TECHNICAL INFORMATION JDE

Type Coffee Vending Machine	Model 9100	T.I. NO 09 - 2017	
Serial Number 74312486	Subject Z4000 ES-FB HOT WATER INLET IMPROVEMENTS	ISSUED FOR (X)	Action Information X

New solution

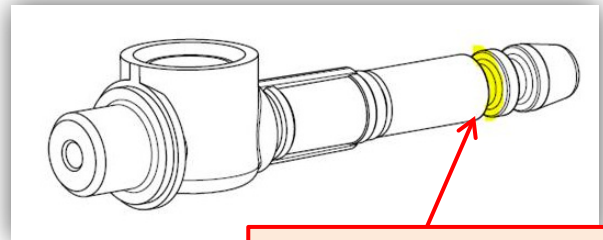
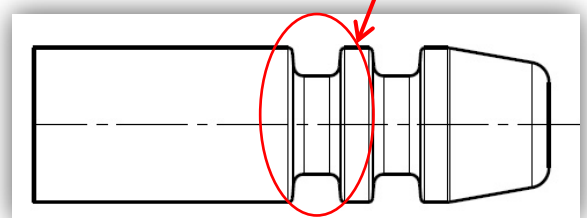
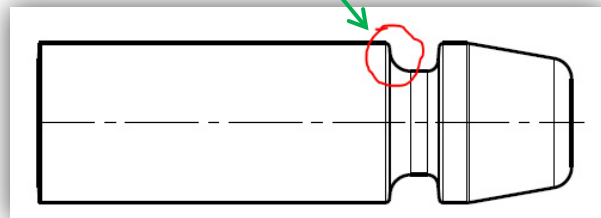
The O-ring seat (marked in yellow colour in the picture below) has been removed, because it is no longer used.

The radius of the gasket seat has been increased: now it smoother then before (see the circle in red).

O-ring seat deleted

Radius of the gasket seat increased

➤ The spare part code is not changed : **260824**

Machines concerned by modification from S/N 74312486.

The **new** solution is retrofittable.
